### World Forum for Harmonization of Vehicle Regulations

## **Proposal for Supplement 2 to the 03 series of amendments to UN Regulation No. 79 (Steering equipment)**

## Supplement 2 to the 03 series of amendments to UN Regulation No. 79 (Steering equipment)

**ACSF C – Case where the lateral movement is initiated automatically (1 Step HMI)**

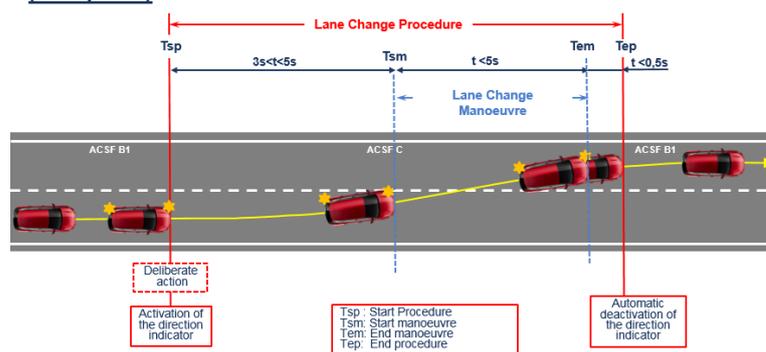
5.6.4.6.4.1. Automatic initiation of the lane change manoeuvre

In case of an automatic initiation the lane change manoeuvre shall commence between 3.0 seconds and 5.0 seconds after the manual activation of the procedure as described in paragraph 5.6.4.6.2. and shown in the Figure below.

**ACSF C – Case where the lateral movement is initiated by a second deliberate action by the driver (2 Step HMI)**

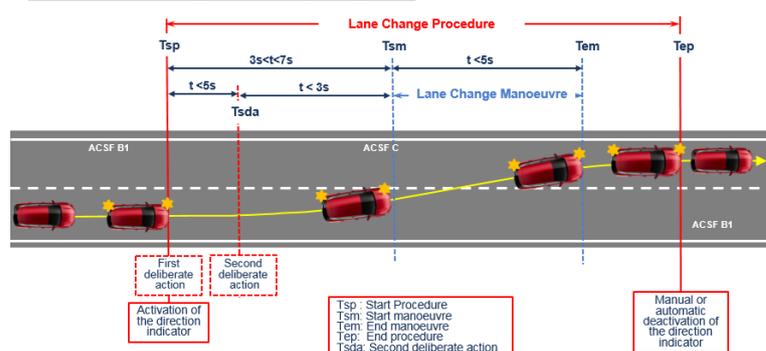
5.6.4.6.4.2. Initiation of the lane change manoeuvre by a second deliberate action

In case of an initiation by a second deliberate action the lane change manoeuvre shall commence between 3.0 and 7.0 seconds after the manual activation of the procedure as described in paragraph 5.6.4.6.2.

Additionally, the lane change manoeuvre shall commence at the latest 3.0 seconds after the second deliberate action as shown in the Figure below.
